DiStefano Request for Dimensional Waiver

Prepared by Phil McDuffie 02Aug 2022

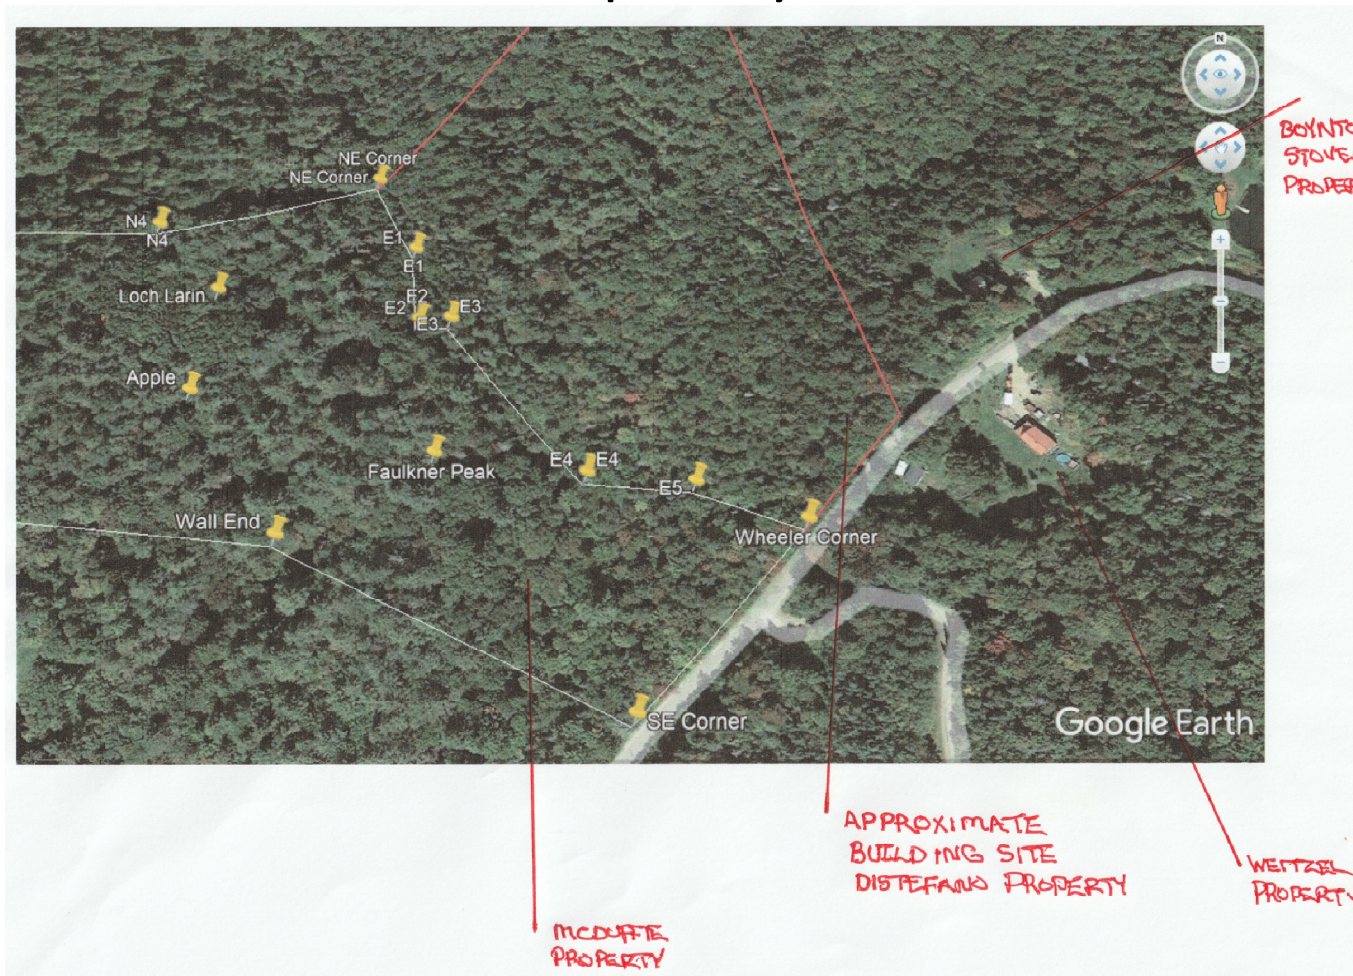
- I proceed to analyze the approved ANR site plan (a building site plan had never been submitted to the town office)
 - My findings verified the setback violation (foundation was approximately 41 from center of Wheeler Road), requirement is 65 feet

- The ANR site plan appears to show the house in the location that it currently sits at (i.e. the plan submitted to ANR shows the foundation is in violation of the setback requirement)

- Revised analysis estimates setback from Boynton-Stover property at approximately 16 feet, requirement is 25 feet
 - Further analysis shows the slope of the site (grade) exceeds the 20% limit specified in Windham's zoning regulations, and should have been considered as an unacceptable location for building a home

Contour Map by FS
Contour Spacing: 1 ft

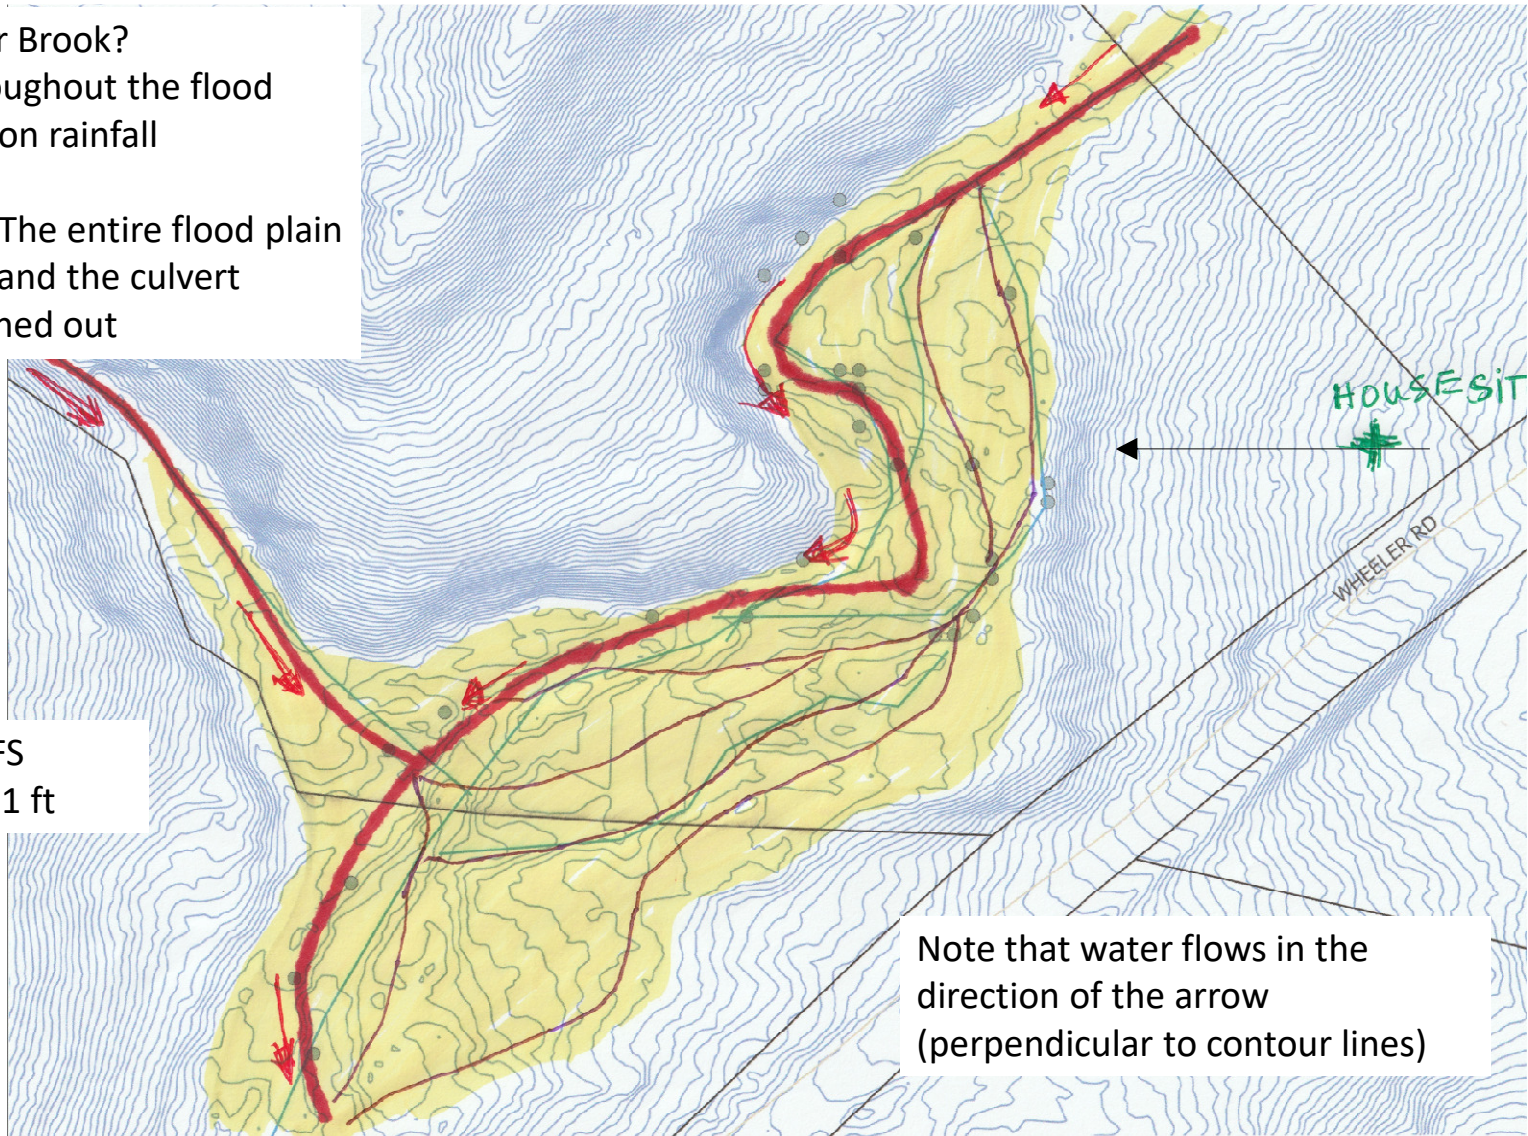
Last June (2021), The entire flood plain
was under water and the culvert
downstream washed out

Note that water flows in the
direction of the arrow
(perpendicular to contour lines)

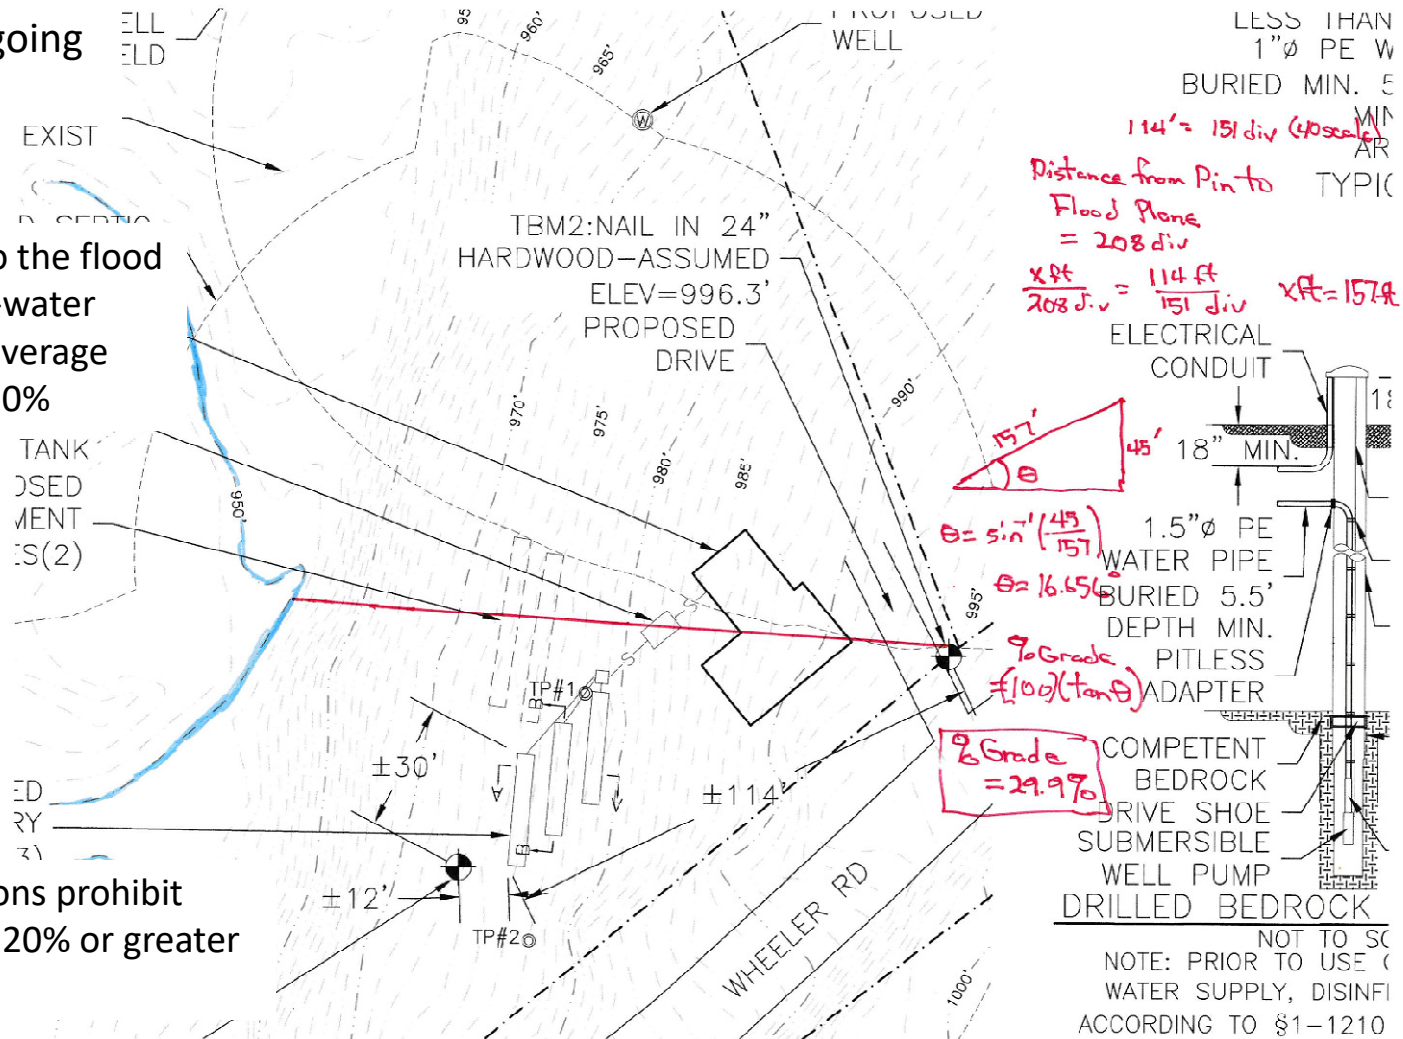
So, what is the slope going across this property?

From the property pin to the flood plane (which is the high-water mark of the brook) the average grade is approximately 30%

Windham Zoning Regulations prohibit development on slopes of 20% or greater (Section 207)

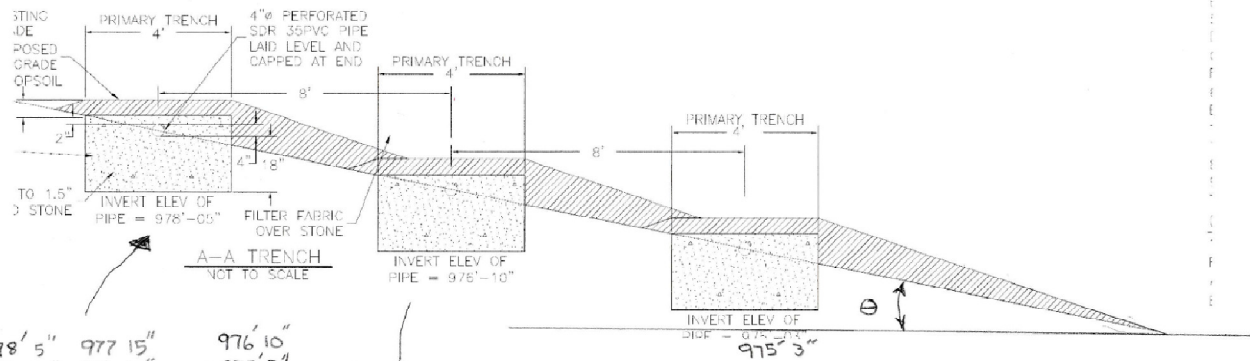
Ave Grade Across Primary Leach Field = $\frac{17.7\% + 19.8\%}{2} = 18.8\%$ grade

$$\text{Percent Grade} = 21.3\%$$

Even the slope going across the primary leach field is calculated at 20%
